Randolph Farms Site Plan No. 820170020

Staff Report Date: 7/7/17

Description

- Request for the approval of a site plan to allow construction of 104 single-family attached townhomes, including 12.5% MPDUs, private roads and alleys, and a centrally located community recreation area;
- Current use: Montrose Baptist Church, the Montrose School and Child Development Center;
- Located at the southeast corner of the intersection of Randolph Road and Putnam Road, within the *North Bethesda/Garrett Park Master Plan* area;
- Approximately 8.44 acres in the RT-15 Zone;
- Applicant: Winchester Homes;
- Application acceptance date: December 12, 2016.

Figure 7: Circulation Plan

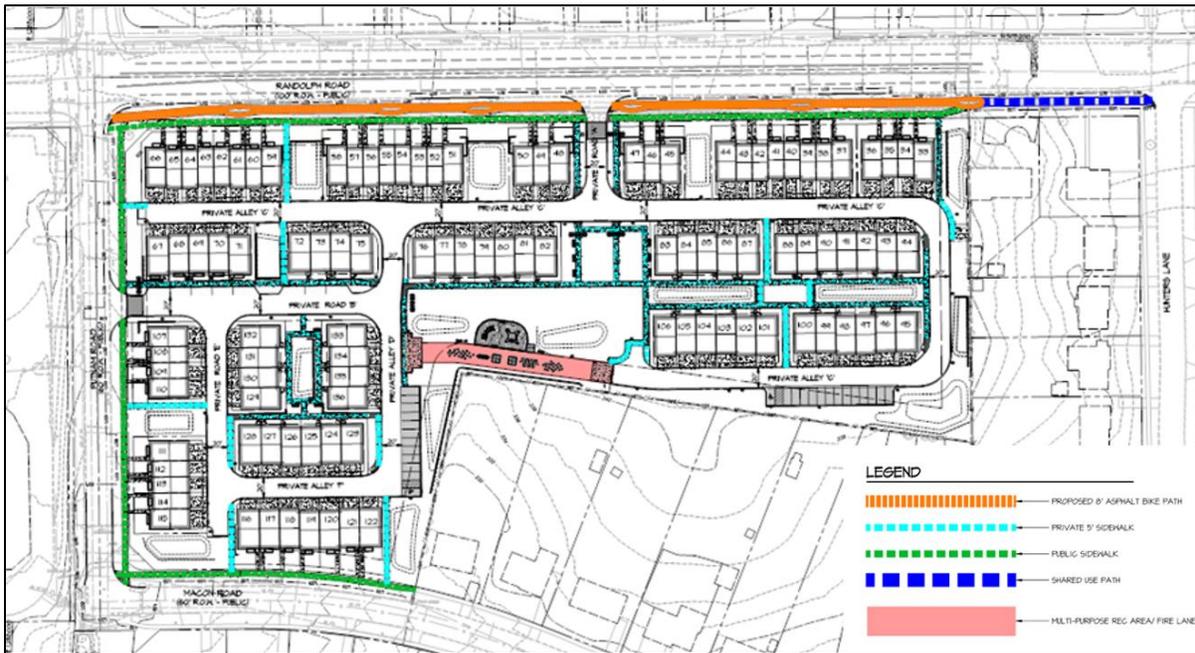
The existing vehicular access to the Property includes two curb cuts from Randolph Road and one from Putnam Road. The proposed development will replace the two existing curb cuts on Randolph Road with one curb cut, and replace the existing curb cut on Putnam Road with a new private street connection into the proposed development. The proposed plan completes the connection between Putnam Road and Macon Road. Adequate internal circulation is provided with the following roads:

The Site Plan provides 274 vehicle parking spaces, which exceed the minimum required 208 spaces for the zone. In addition, two inverted-U bike racks will be provided at the central recreation area. Figure 7 illustrates the circulation plan for the entire site. The internal roads will provide access to all buildings, parking lots and garages and the network of sidewalks will allow

pedestrians to access all buildings, green spaces and the surrounding public roads. Staff finds the pedestrian and vehicular circulation to be adequate, safe and efficient.
